Access Compliance Report

Public Rights-of-Way

(Curb Ramps)

Intersection ID: 27556	Main Street: LEDERER_AV	Cross Street: QUEARY_CT	Location: NW
ADA ID: 54A05ED0ED4A	Ramp Type: BlendTrans2	Initial Pass/Fail: Fail	Overall Compliance: No
Severity Score: 12.5			
Codes/Mitigation Info/Possible Solution		Field Measurements/Component Compliance

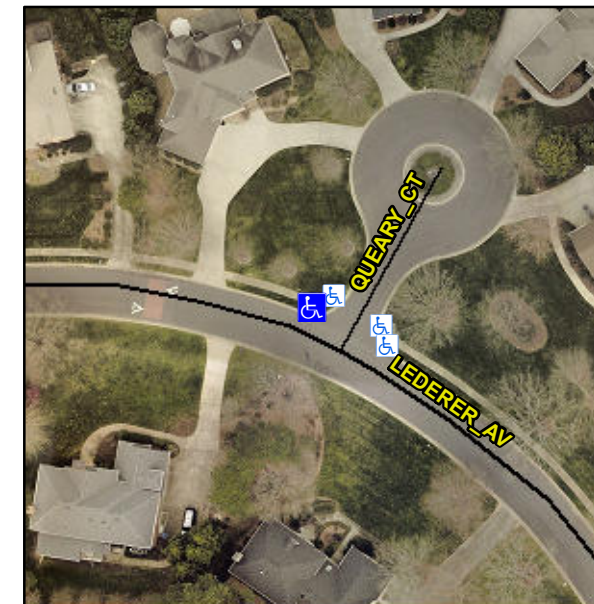
Not Found, R304.5.3

Compliance	Description	Data	Compliance	Description	Data
N/A	Ramp Length (in)	48.0	Yes	BlendTrans Slope (%)	0.4
Yes	Ramp Width (in)	48.0	No	BlendTrans XSlope (%)	6.3
N/A	Flare Type LT	N/A	N/A	Flare Type RT	N/A
N/A	Flare Slope LT (%)	N/A	N/A	Flare Slope RT (%)	N/A
N/A	Flare Traversable LT?	N/A	N/A	Flare Traversable RT?	N/A
N/A	Landing Length (in)	N/A	N/A	DWS Provided?	N/A
N/A	Landing Width (in)	N/A	N/A	DWS Contrast?	N/A
N/A	Landing Slope (%)	N/A	N/A	DWS Length (in)	N/A
N/A	Landing X Slope (%)	N/A	N/A	DWS Full Width?	N/A
N/A	Landing Curb? (Y/N)	N/A	N/A	DWS Offset (in)	N/A
N/A	Shared Landing?	N/A			
N/A	Gutter Ponding?	N/A	N/A	Gutter Slope (%)	N/A
N/A	Gutter Lip Ht (in)	N/A	N/A	Gutter X Slope (%)	N/A
N/A	Painted X Walk1?	No	N/A	Painted X Walk2?	N/A
	X Walk 1 Direction	To SW		X Walk 2 Direction	N/A
	X Walk 1 Width (in)	N/A		X Walk 2 Width (in)	N/A
	X Walk 1 Slope (%)	4.4		X Walk 2 Slope (%)	N/A
	X Walk 1 X Slope (%)	2.7		X Walk 2 X Slope (%)	N/A

N/A	Ramp inside XWalk1?	N/A	N/A	Ramp inside XWalk2?	N/A
	Road Slope (%)	2.7		Clear Space?	N/A
	Road X Slope (%)	4.4	N/A	Clear Space to XWalk (in)	N/A
N/A	Any Obstructions?	N/A	N/A	Storm Grate/Utility Hazard?	N/A
	Obstruction Type			Storm Grate/Utility Type	
		N/A			N/A
			Yes	Surface Condition? (G/P)	Good
			No	Curb Slope (%)	10.9

Remove & Replace Curb Ramp With Two New Directional Ramps or Equivalent.
